Request For Information

RFI-068

Subject: BP3 Prom Drain Locations
Project: Steamboat - BV BP Promenade and Goldwalk
Address: 2305 Mount Werner Circle
Steamboat Springs CO 80487 USA
Phone:
To: Zach Ray
MTech Mechanical Technologies Group, Inc.
From: Saunders Construction, LLC Alec Hallman

1A-C.301

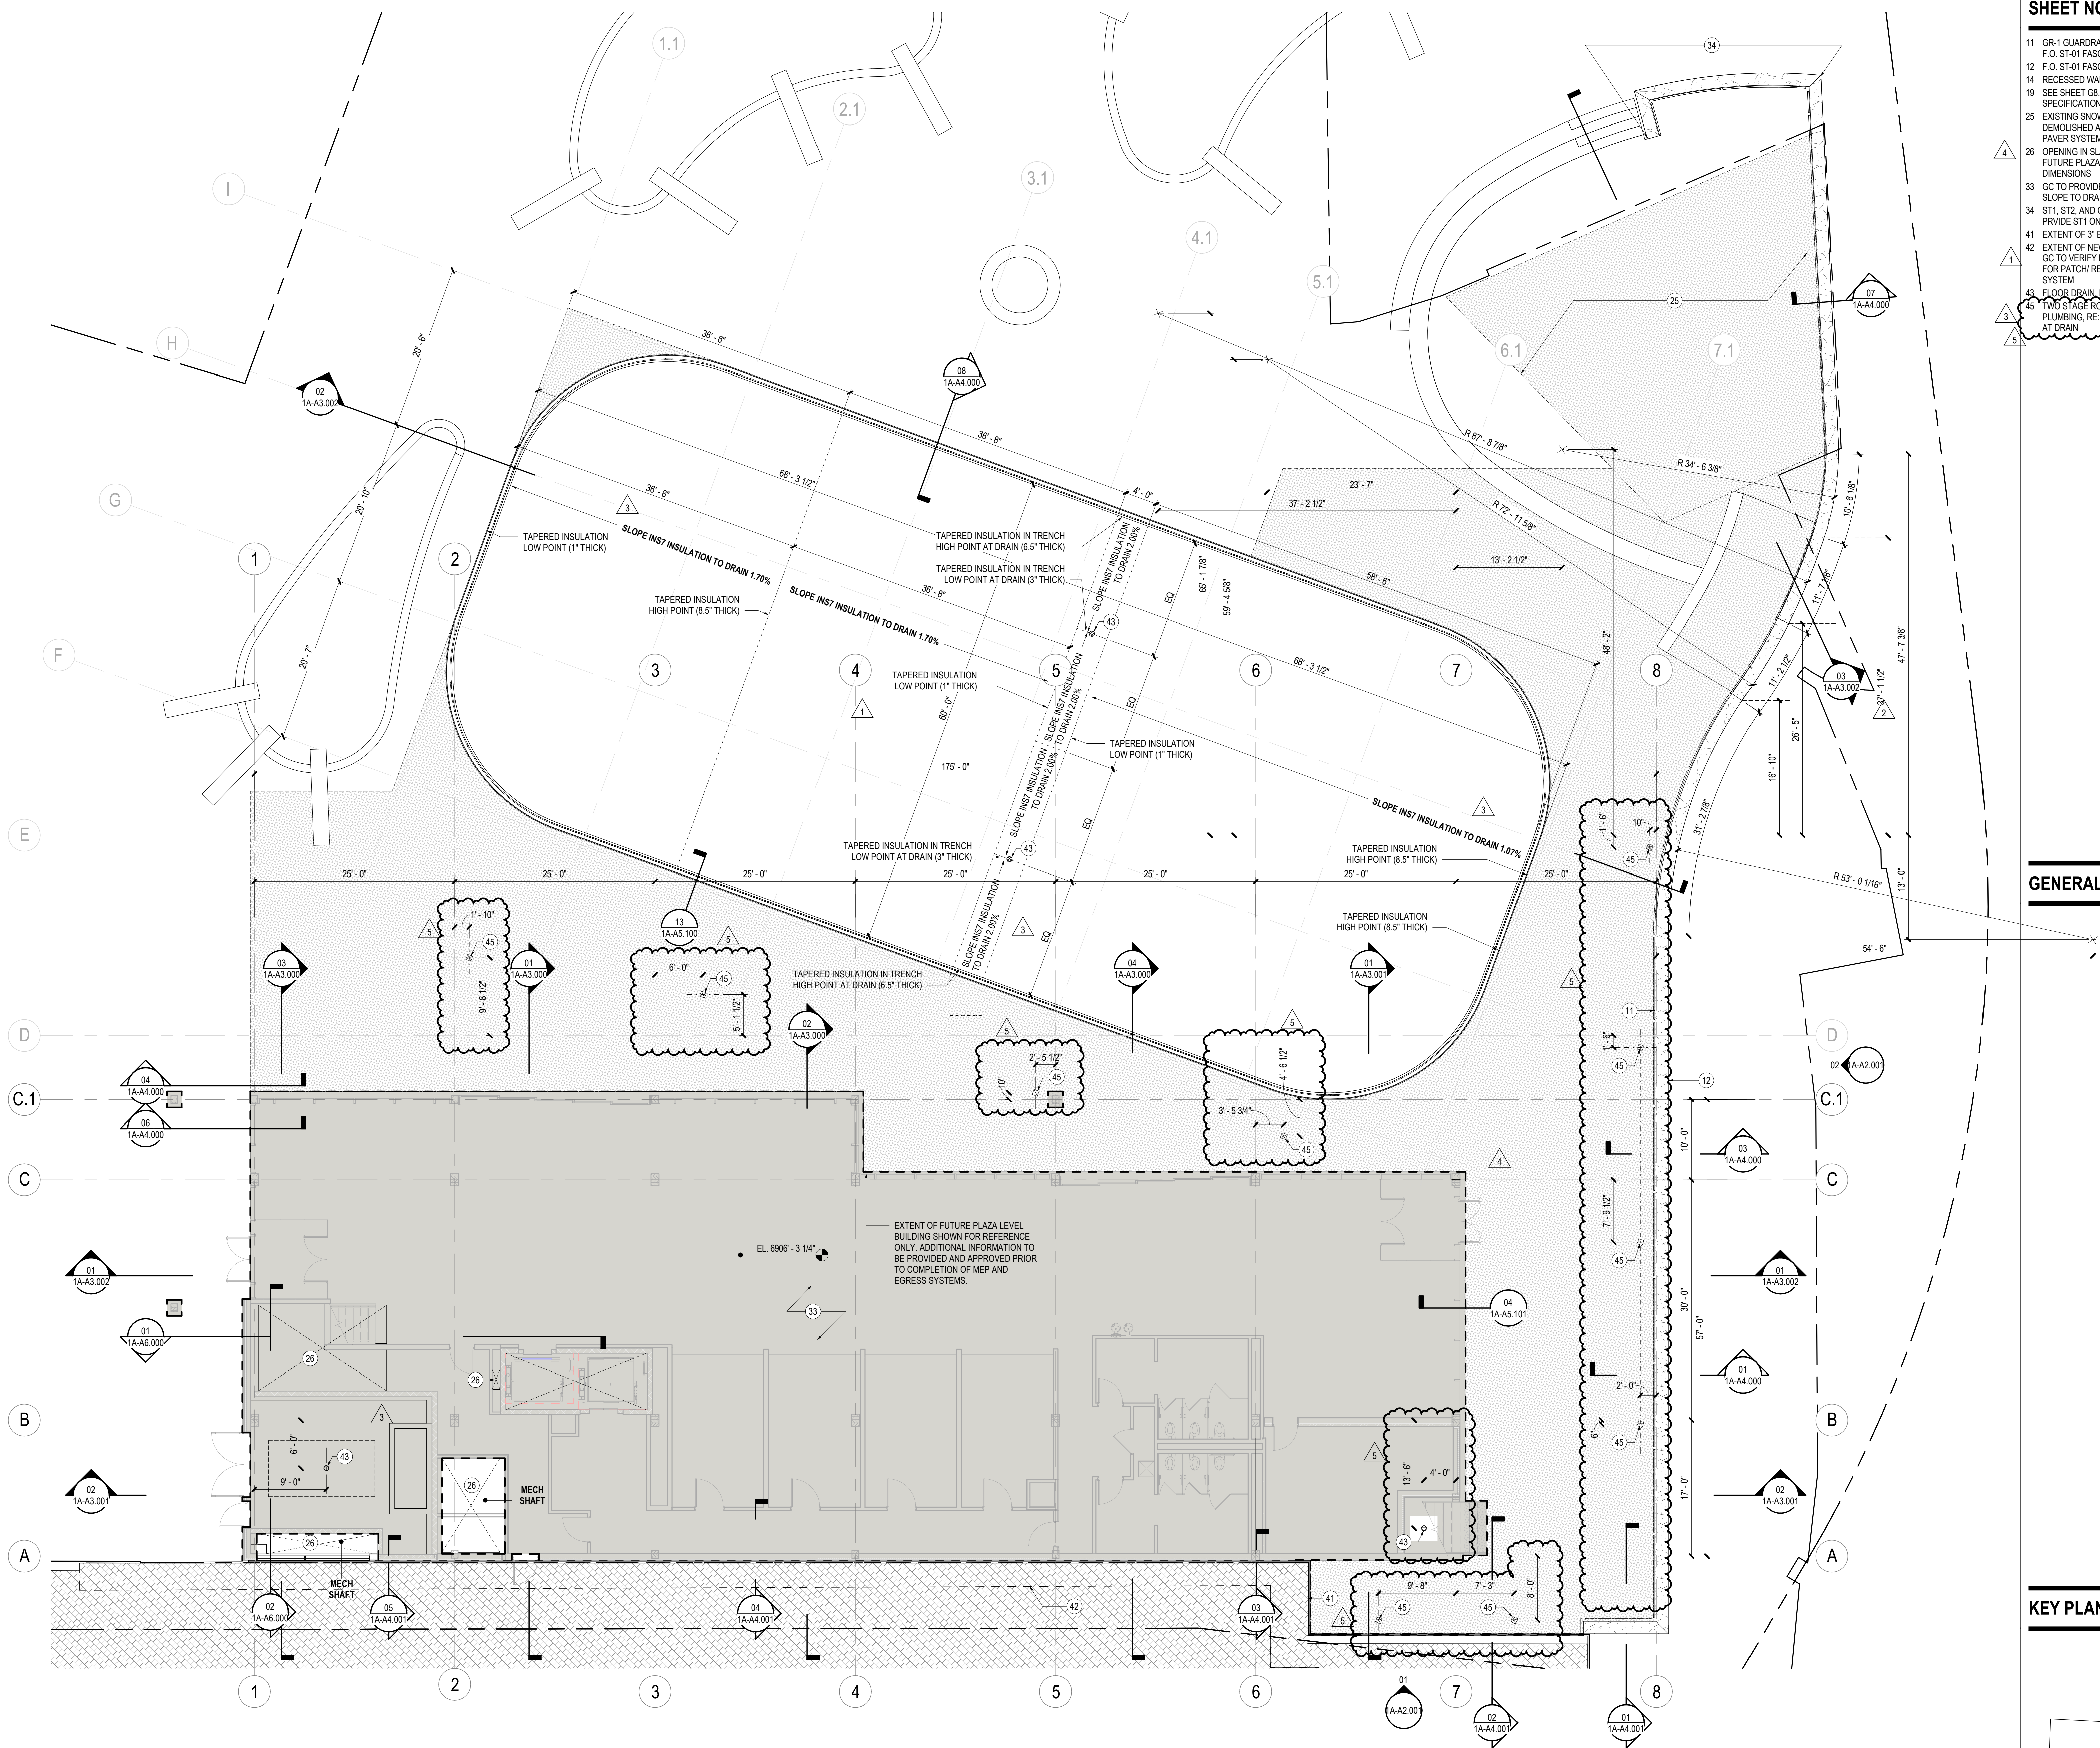
Ref attached correspondence, the plaza drain locations and associated piping need to be updated.

Please advise changes at plaza drain locations.

DRAIN LOCATIONS HAVE BEEN REVISED PER UPDATED PLAZA BUILDING FOOTPRINT. DIMENSIONS FOR DRAIN LOCATIONS ADDED TO A1-A1.201. ONE DRAIN ADDED AT PINCH POINT BETWEEN ICE RINK AND PLAZA SLAB. ONE DRAIN REMOVED FROM PROMENADE ROOF ALONG EAST PROMENADE WALL AND ONE RELOCATED SLIGHTLY FURTHER NORTH (TO AVOID ELECTRICAL ROOM). TWO DRAINS ADDED ON SOUTH SIDE NEAR OSP TO FACILITATE REMOVAL OF DRAINS ABOVE ELECTRICAL ROOM. ASSOCIATED PIPING REVISED. SOME UNDERGROUND PIPING REMOVED UNDER ELECTRICAL ROOM. A NEW SHEET (1A-A1.201P) ADDED TO SET FOR CLARITY ON PLAZA SLOPES.

1A-C.300 - OVERALL GRADING PLAN - UPDATED GRADING AND DRAIN LOCATIONS
1A-C.301 - SEGREGATED GRADING PLAN - UPDATED GRADING AND DRAIN LOCATIONS
1A-A1.201 - PROMENADE - CONSTRUCTION PLAN - LEVEL 01 - UPDATED DRAIN LOCATIONS, ADDED ONE DRAIN IN PLAZA BUILDING SLAB THAT WAS SHOWN ON PLUMBING BUT NOT ARCHITECTURE (UNDER FUTURE STAIR)
1A-P1.199 - PROMENADE - PLUMBING UNDERGROUND PLAN - LEVEL 00 - REVISED ASSOCIATED PLUMBING
1A-P1.200 - PROMENADE - PLUMBING PLAN - LEVEL 00 - UPDATED DRAINS AND PLUMBING
1A-P1.201 - PROMENADE - PLUMBING PLAN - LEVEL 01 - UPDATED DRAINS AND PLUMBING

1A-P1.201

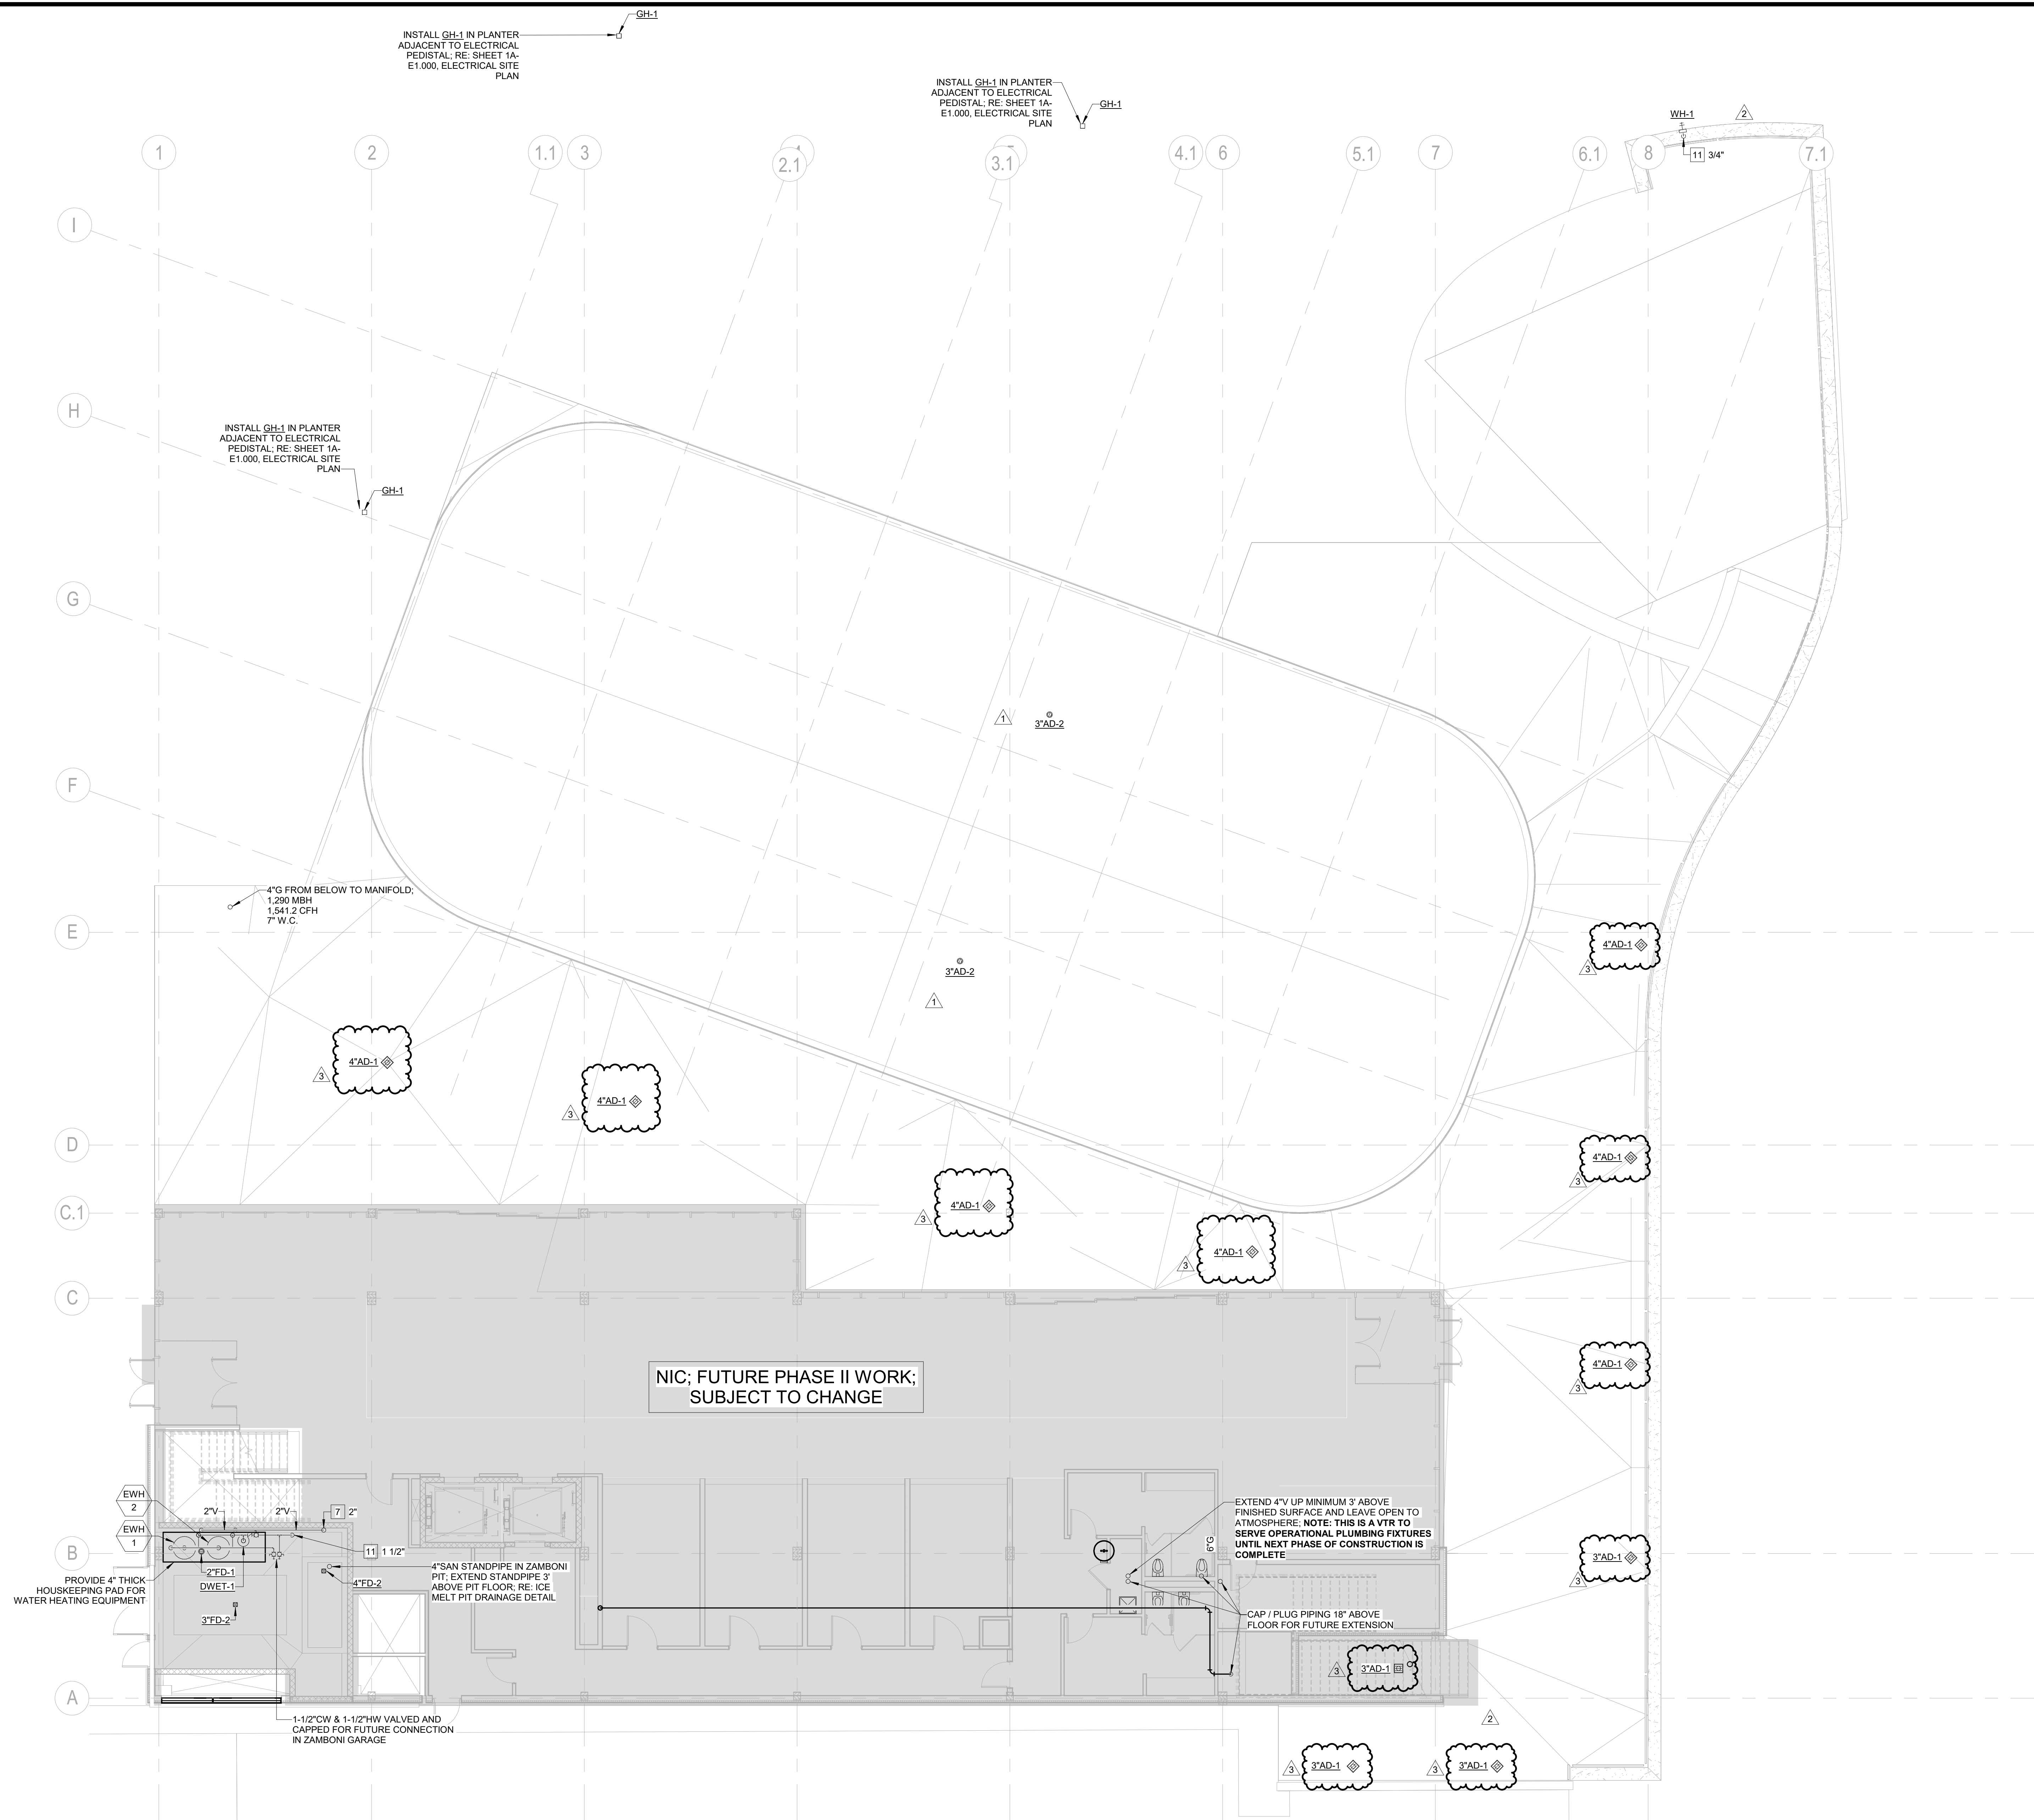
Can you send us an RFI requesting drain locations updates and we'll get it cleaned up? 1A-P1.201 shows an area drain right on the edge of the building. We'll need to move it out into the plaza and recheck our grading.
